Access Compliance Report

Public Rights-of-Way (Curb Ramps)

Intersection ID: 46206	Main Street: LOROPETALUM_RD	Cross Street: SNOWBELL_CT	Location: SE
ADA ID: FB5CB211C87E	Ramp Type: PerpDiag	Initial Pass/Fail: Fail	Overall Compliance: No
Severity Score: 21.25			
Codes/Mitigation Info/Possible Solution		Field Measurements/Component Compliance

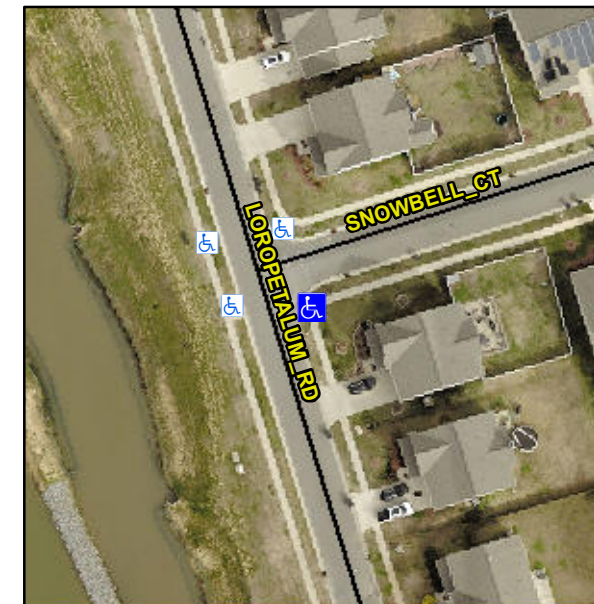
Not Found, R304.5.1, R304.2.2

Compliance	Description	Data	Compliance	Description	Data
N/A	Ramp Length (in)	72.5	No	Ramp Slope (%)	9.4
No	Ramp Width (in)	47.5	Yes	Ramp XSlope (%)	0.4
N/A	Flare Type LT	N/A	N/A	Flare Type RT	N/A
N/A	Flare Slope LT (%)	N/A	N/A	Flare Slope RT (%)	N/A
N/A	Flare Traversable LT?	N/A	N/A	Flare Traversable RT?	N/A
N/A	Landing Length (in)	N/A	N/A	DWS Provided?	N/A
N/A	Landing Width (in)	N/A	N/A	DWS Contrast?	N/A
N/A	Landing Slope (%)	N/A	N/A	DWS Length (in)	N/A
N/A	Landing X Slope (%)	N/A	N/A	DWS Full Width?	N/A
N/A	Landing Curb? (Y/N)	N/A	N/A	DWS Offset (in)	N/A
N/A	Shared Landing?	N/A			
N/A	Gutter Ponding?	N/A	N/A	Gutter Slope (%)	N/A
N/A	Gutter Lip Ht (in)	2.0	N/A	Gutter X Slope (%)	N/A
N/A	Painted X Walk1?	No	N/A	Painted X Walk2?	No
	X Walk 1 Direction	To N		X Walk 2 Direction	To SE
N/A	X Walk 1 Width (in)	N/A	N/A	X Walk 2 Width (in)	N/A
	X Walk 1 Slope (%)	2.7		X Walk 2 Slope (%)	1.3
	X Walk 1 X Slope (%)	3.9		X Walk 2 X Slope (%)	0.7

Remove & Replace Curb Ramp With Two New Directional Ramps or Equivalent.
